#### **CERTIFICATE OF APPROPRIATENESS**

Proposal: Alteration – Windows - Work Already Done - Certificate of Remediation (COR)

**ITEM A5** 2007 Kane Street Old Sixth Ward

January 16, 2025 HPO File No. HP2024\_0307

### **EXISTING CONDITION - WEST ELEVATION**

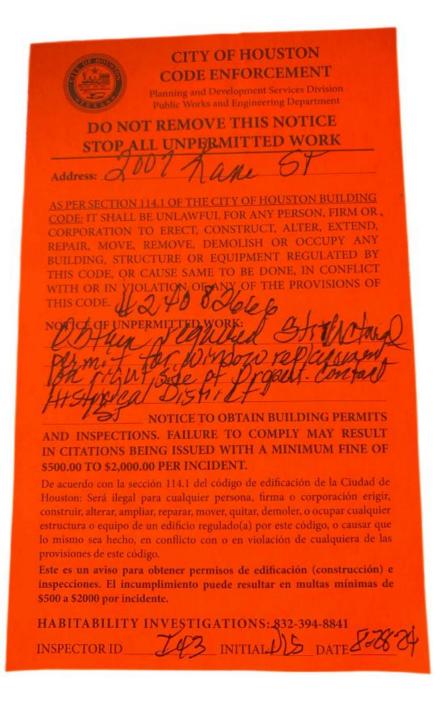
West Elevation - Vinyl Windows

Fixed Windows highlighted in red were replaced

• Inset existing windows so that upper sash is inset at least 1¾ inches from Exterior Casing of Window Unit, see Attached Window Diagram.

# Existing North Elevation

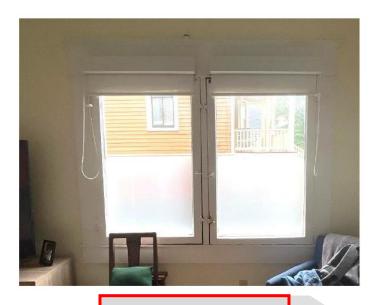
Condition of COR: Add Windowsill to West Elevation Double Windows to resemble North Elevation Window, marked in Yellow.

Add 2" x 4" or similar, windowsill to double window, to be compatible with North elevation windowsill (Front).

### **INTERIOR OF WINDOWS**

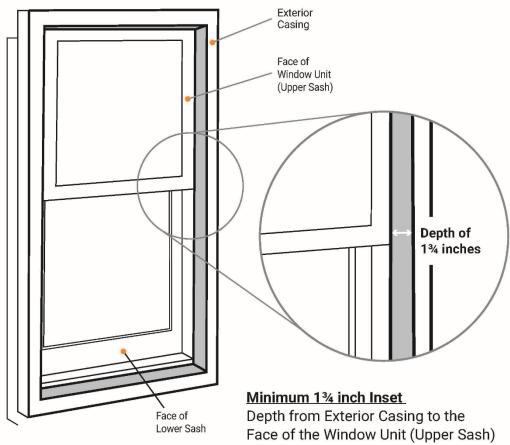
Windows must be 1-over-1 (equally horizontally divided)

134 inch minimum inset for Fixed Window
